# FALCON MEADOWS AT BENT GRASS

A PARCEL OF LAND, BEING A PORTION OF THE WEST HALF OF SECTION 1, T.13S., R.65W., OF THE 6TH P.M., COLORADO SPRINGS, EL PASO COUNTY, STATE OF COLORADO  
**PUD PRELIMINARY PLAN**

# PUD V\_2 planning only.pdf Markup Summary 1-27-2021

**OVERALL SITE PLAN/  
ADJACENT PROPERTY OWNERS/  
TRACT MAP**

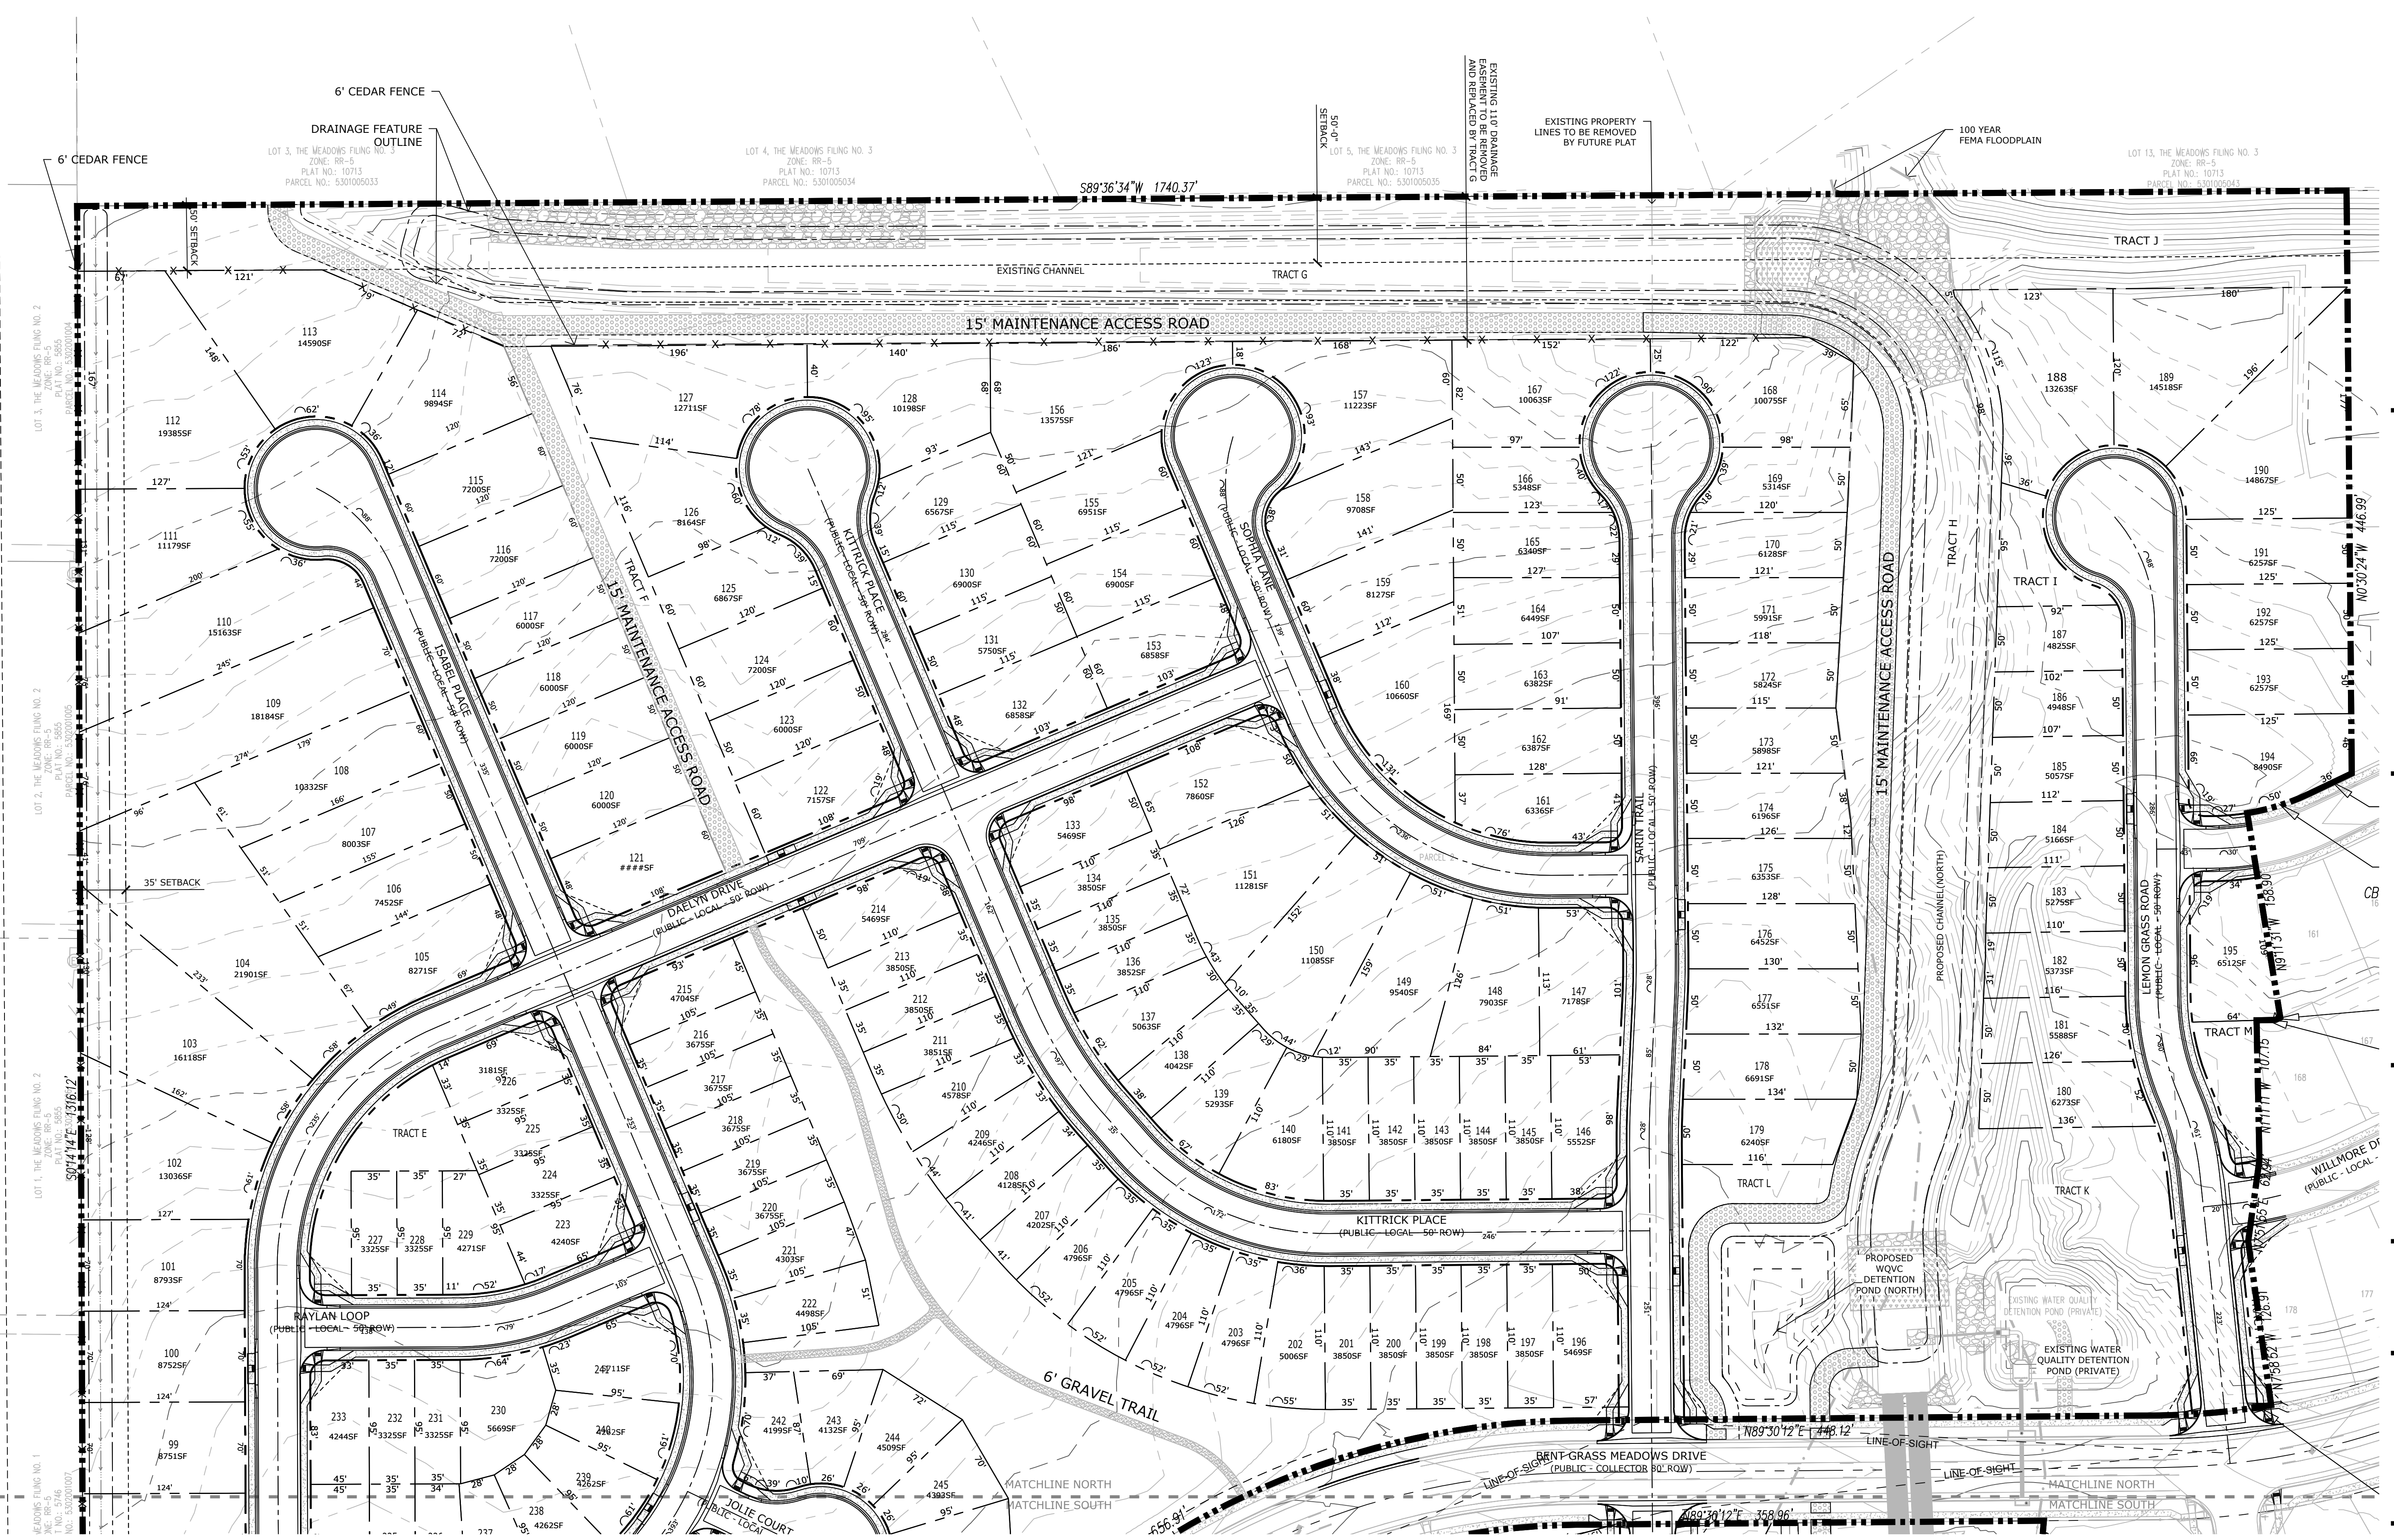
Do you want to verify that the BGMD will own and maintain tract D if the WHMD is providing water and WW? OR add Both Districts as Possible owners & maintenance

dimension all tracts please

landscape plan shows split rail,, your identifying cedar fencing here . Please clarify what is proposed with a detail and state who will install it and maintain it.

and Associated District water /ww improvements

#### PRELIMINARY LANDSCAPE DETAILS & NOTES

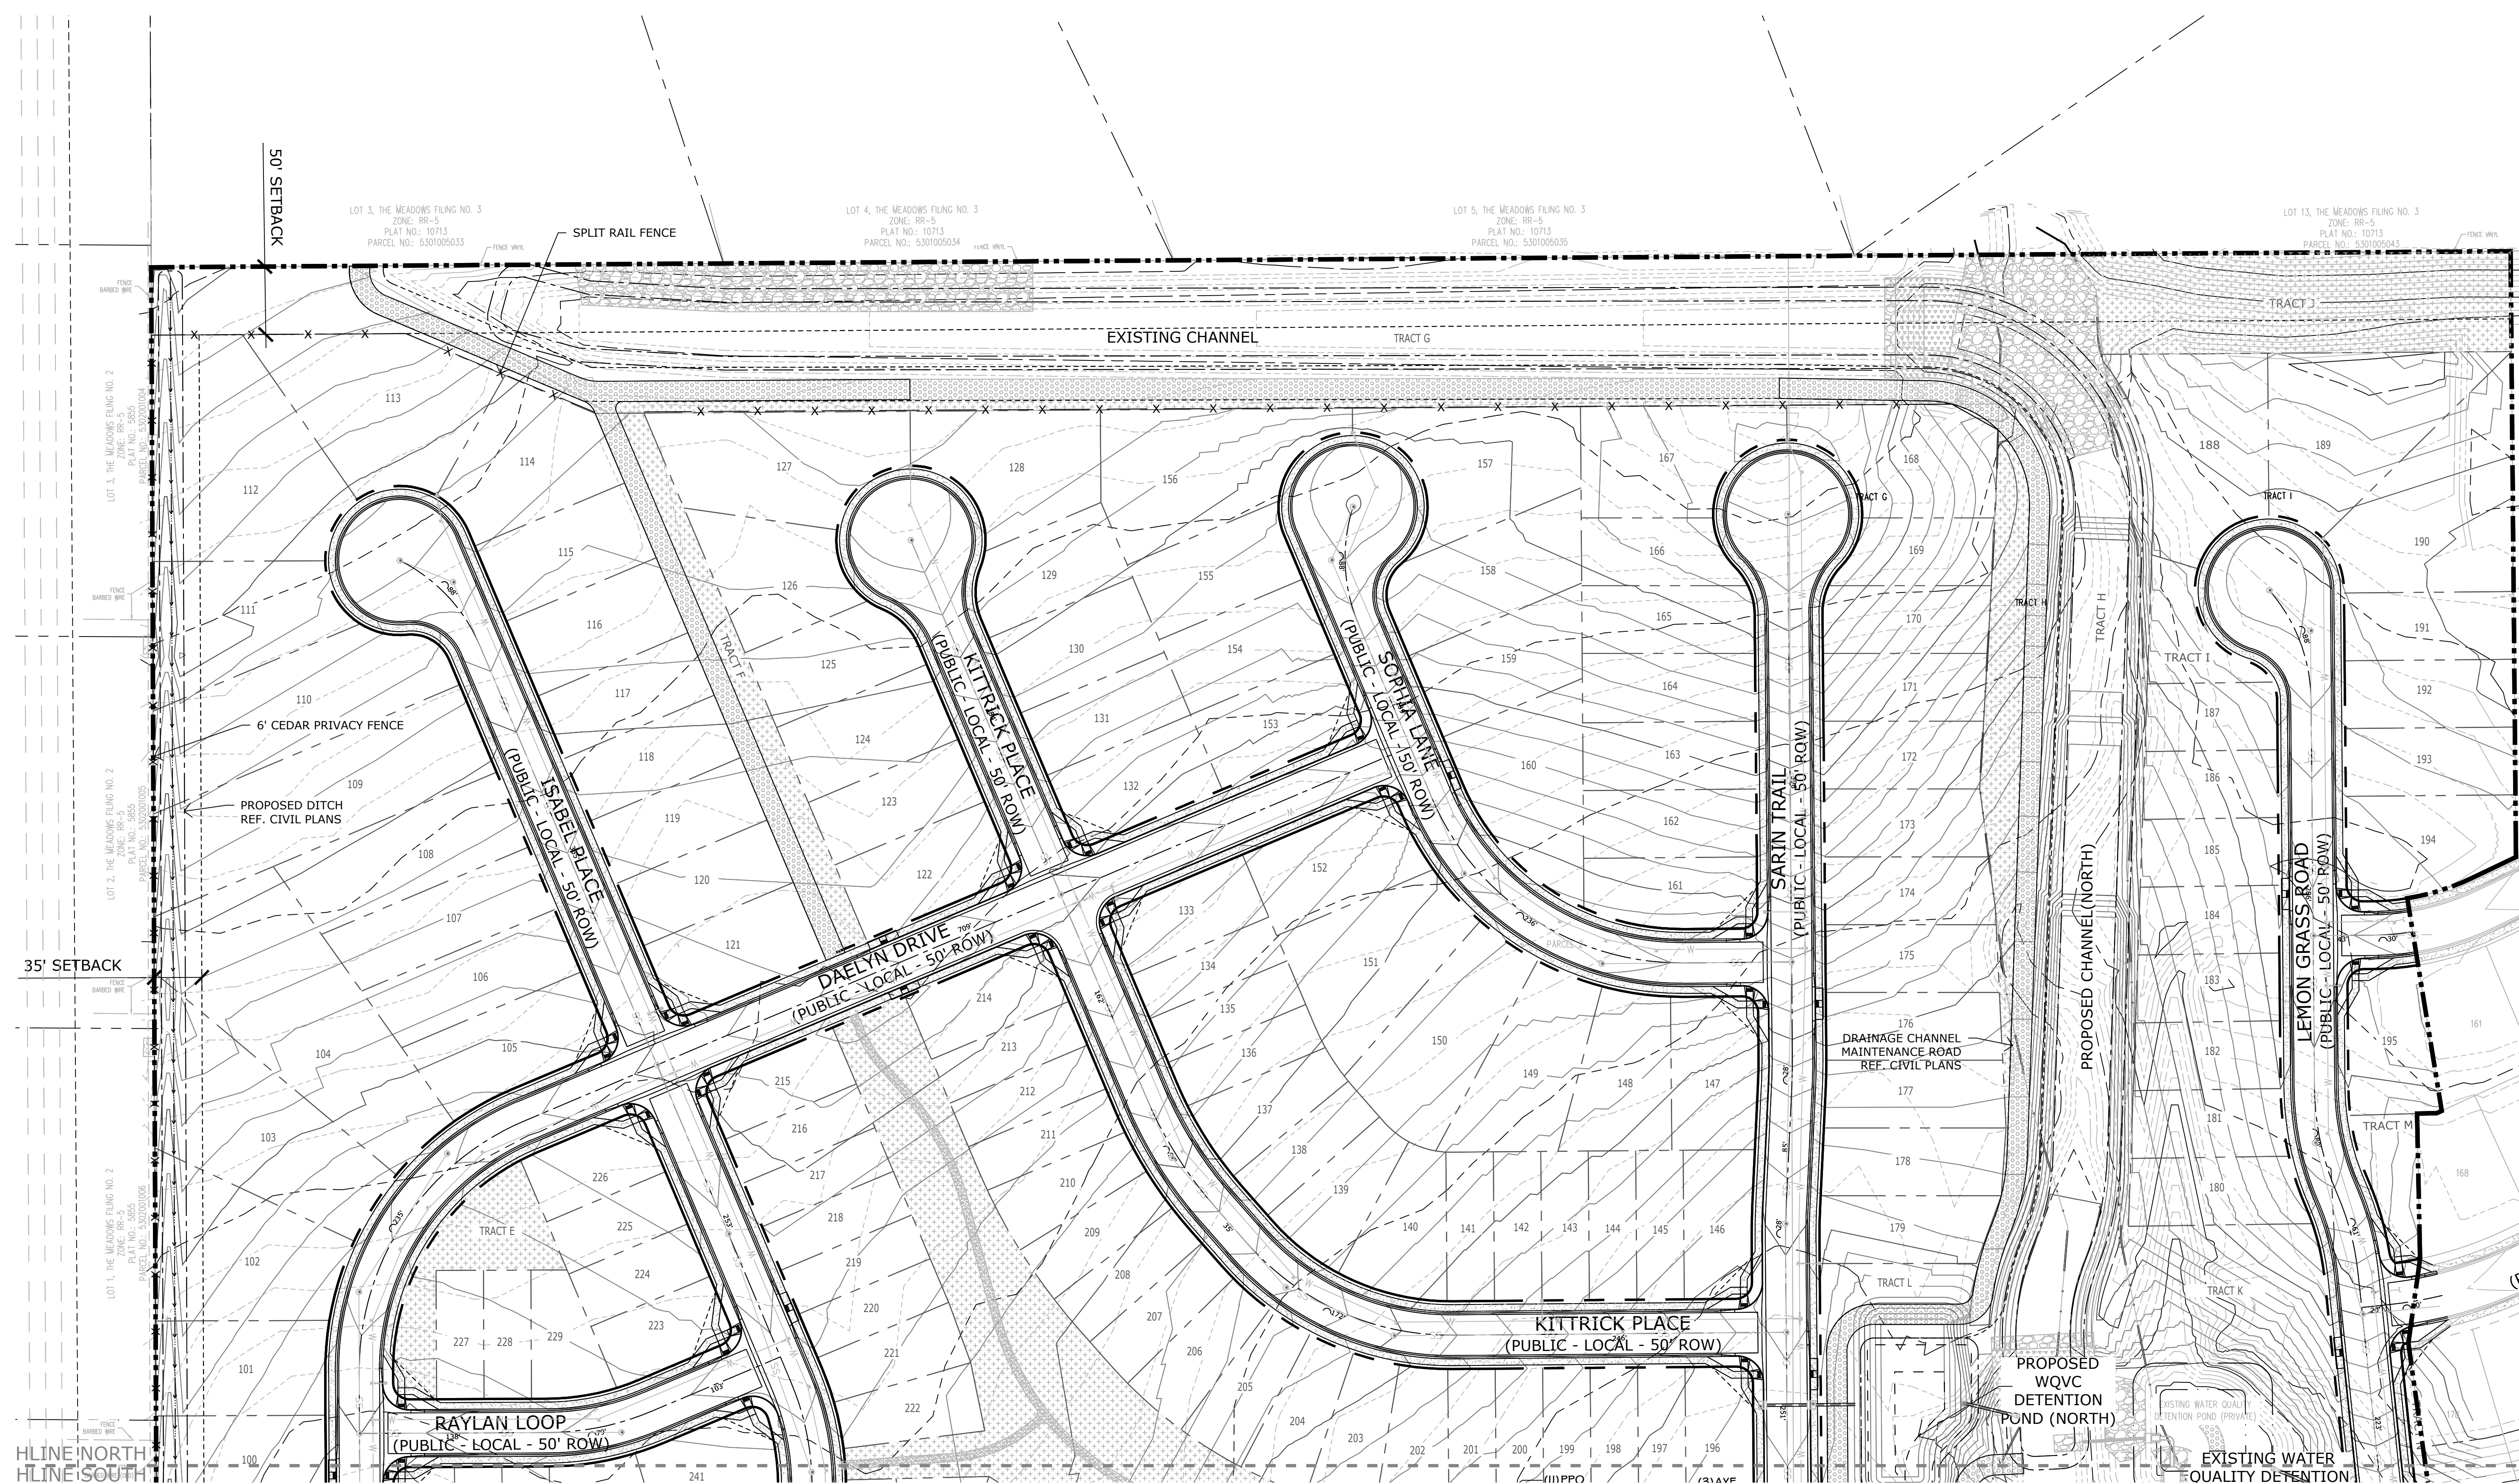
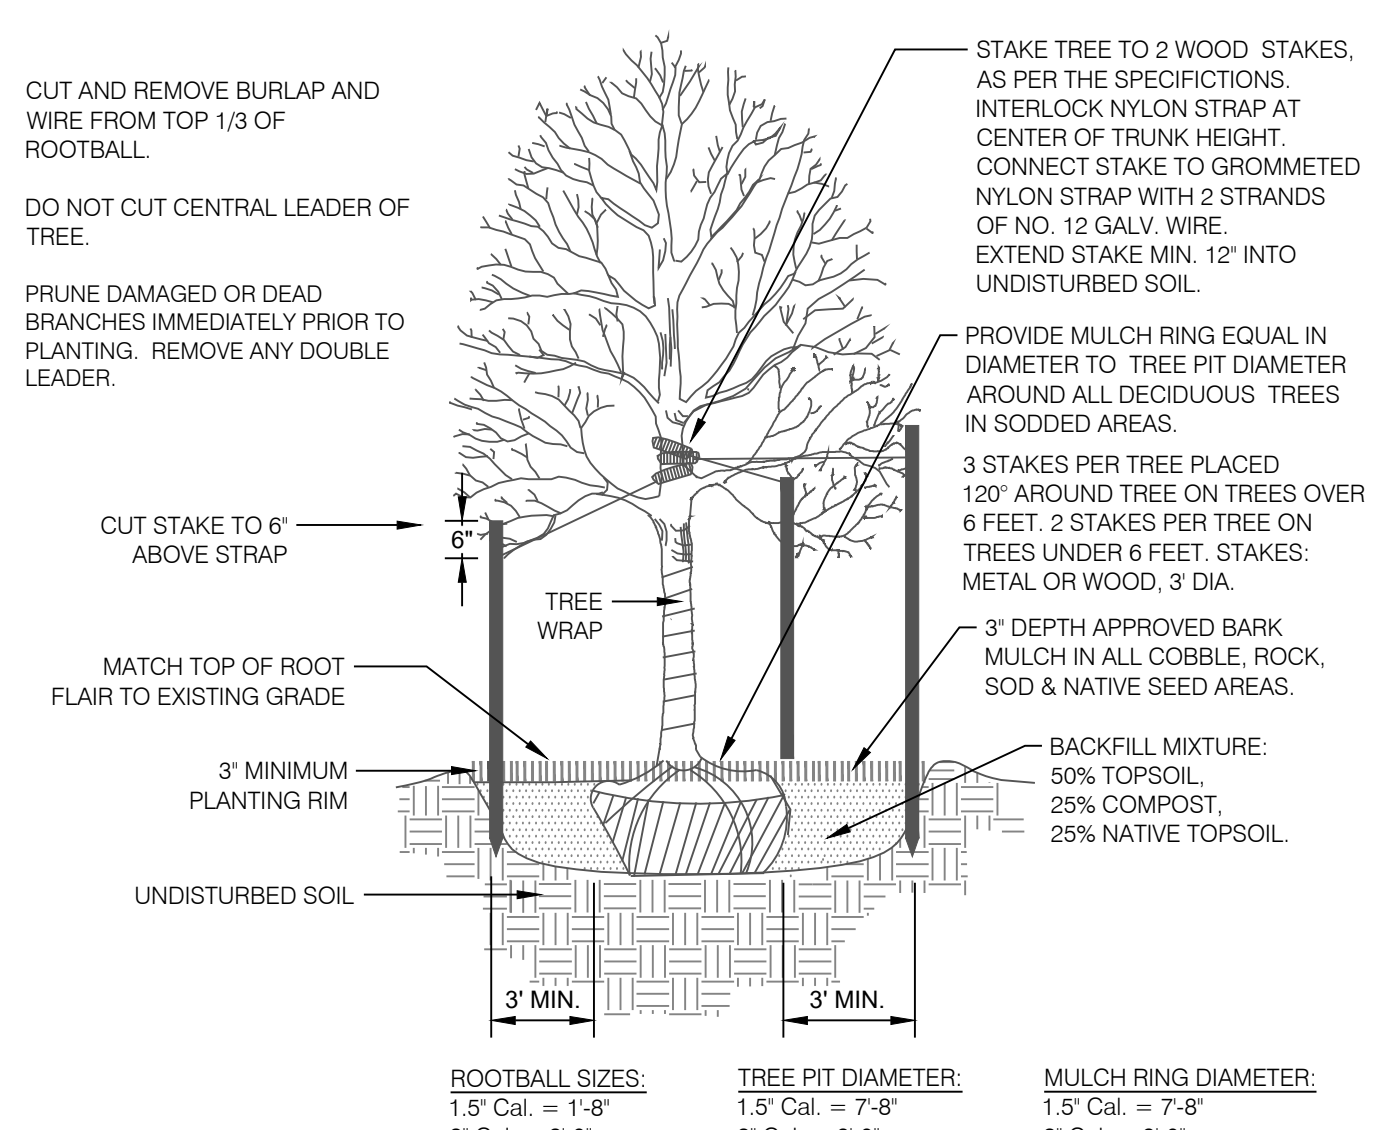
split rail fence is called out on sheet 11
